# **Report on aspects of SESRO dam design**

**January 2024**

**Prof. Chris Binnie MA, DIC, Hon DEng, FREng, FICE, FCIWEM**

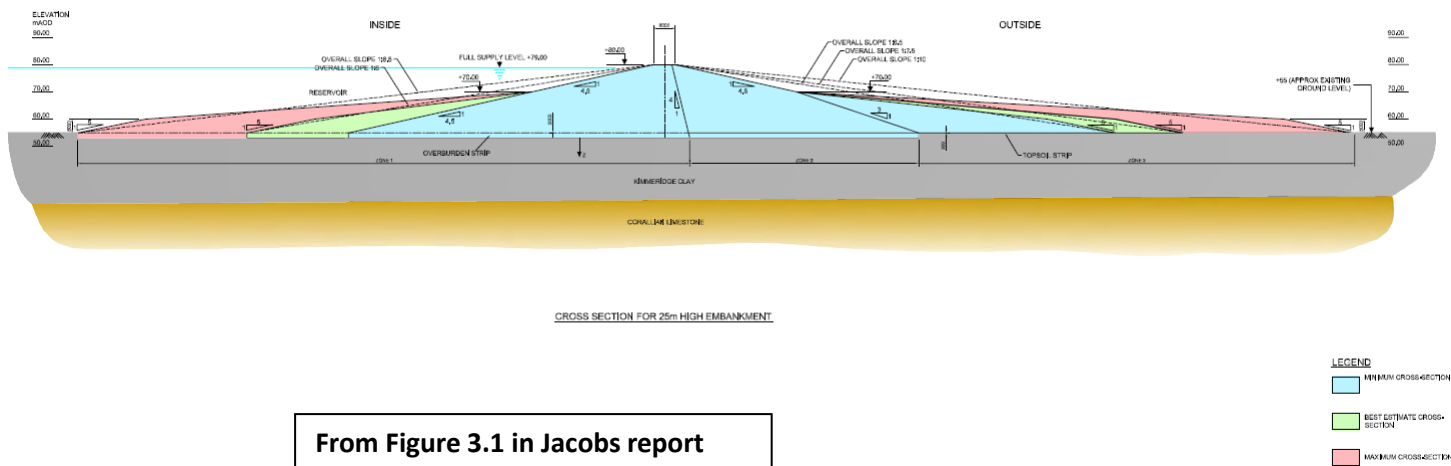
Table 3.8 of Jacobs’ report shows potentially wide variations in the upstream and downstream slopes, dependent on the outcome of the trial embankment and the final stability analyses, as shown in their Table 3.8 and Figure 3.3, both copied below:

I note that the difference between the best estimate and maximum slope values considered by Jacobs are similar to the flattening of the slopes of Abberton reservoir, following a slip failure during construction, as I referred to earlier.

In turn the change to the maximum (flatter) slopes could also lead to an increase in riprap and drainage material. It would be reasonable to assume a similar percentage increase, ie about 30%. That would result in about a 30% increase in embankment cost.

**Figure 5.1 Embankment settlement**

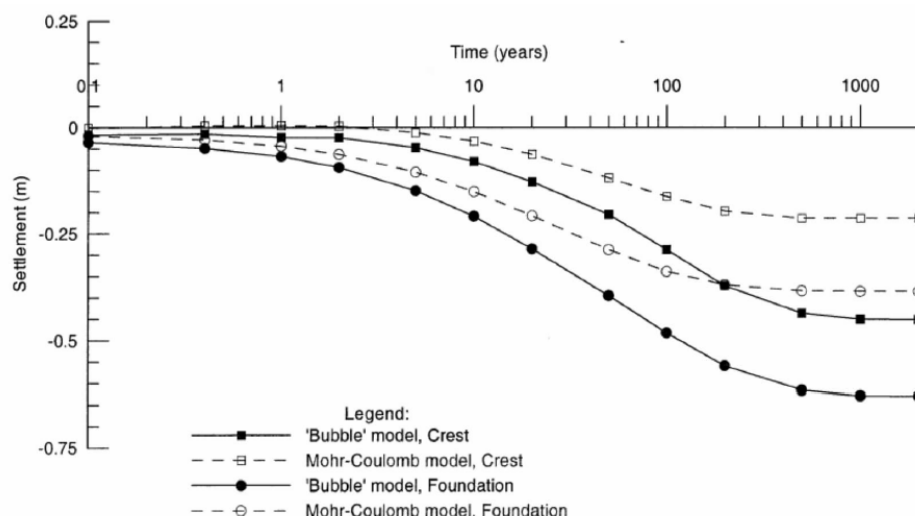
High clay embankments will settle/consolidate over the life of the dam. With the clay found at this site this consolidation/settlement may take some time. The long term amount would need to be predicted and the dam crest built to incorporate this amount.

The Jacobs 2007 Draft Preliminary Design Report figure 5.1 see below shows a plot of the foundation and crest settlement over a period of 1,000 years. The text says “After 100 years the predicted crest settlement of the 25m high embankment is approximately 0.25m.”<sup>22</sup>

2. **Crest settlement:** the preliminary design makes inadequate allowance for crest settlement of the 25 m high clay embankment, placed on a compressible clay foundation. This could be of the order of 0.5m so would need to be allowed for in the design and would add significantly to earthfill quantities and hence cost.

**Figure 2.3 Undrained shear strength test data and design lines**

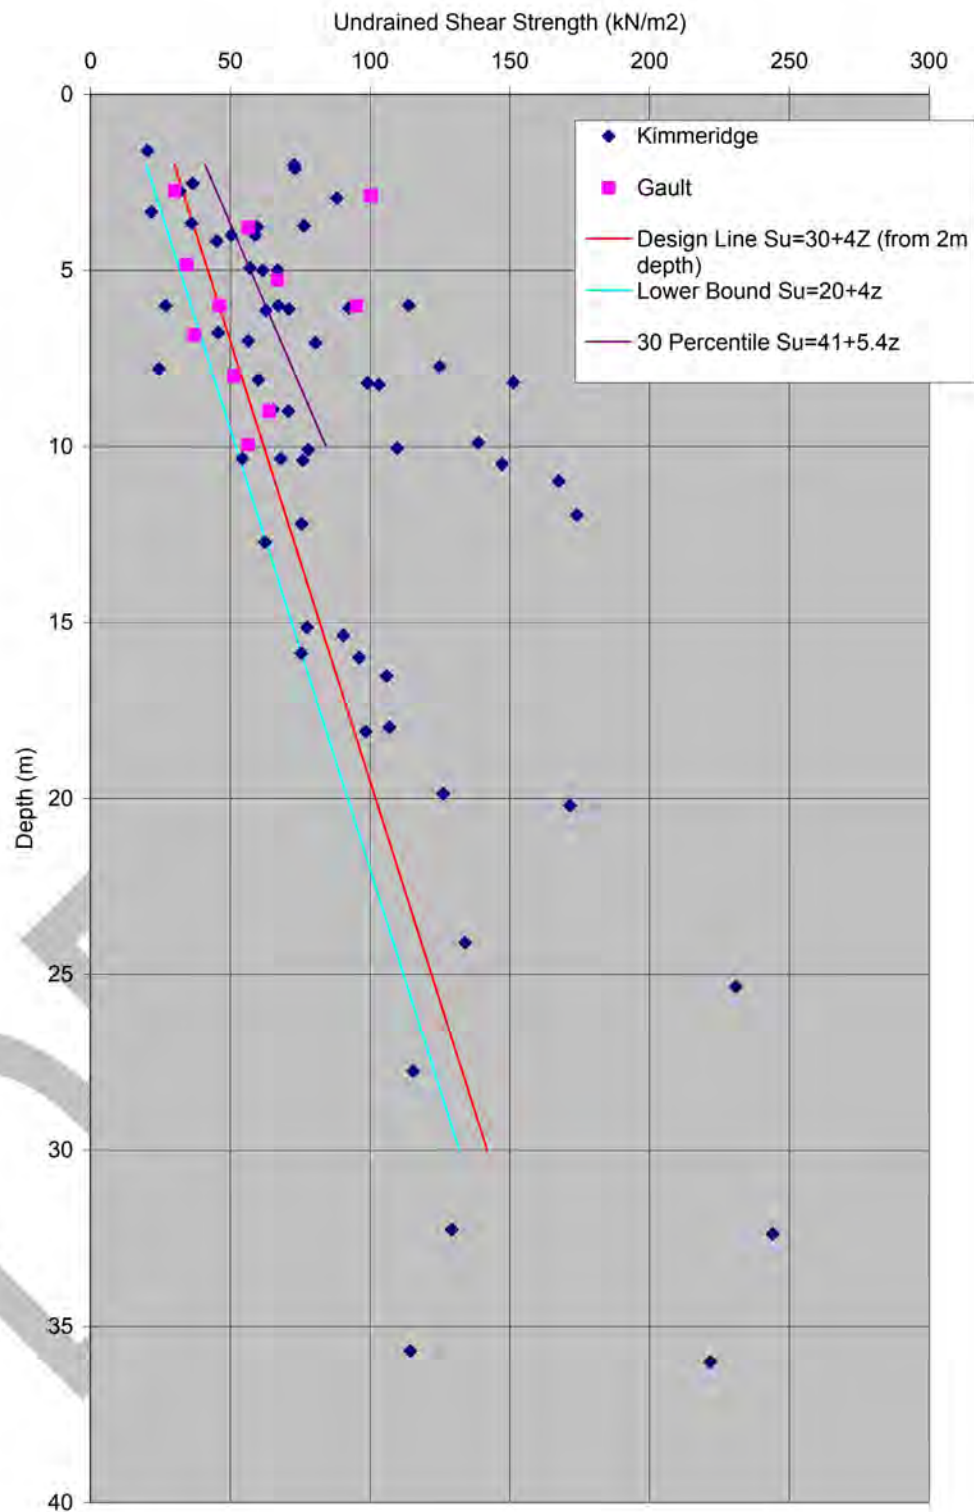
“The slope angles as currently defined are based on the 10 percentile strength profile for the foundations.” 3.4.3. “There is a possibility that the trial embankment would show this to have been an overly conservative estimate of the foundation strength.” 3.4.3

However, those cross sections are based on there being 10 % of soil test results being weaker, see Figure 2.3 page 2-13. Is it possible that this proves to be too risky and flatter slopes are required?
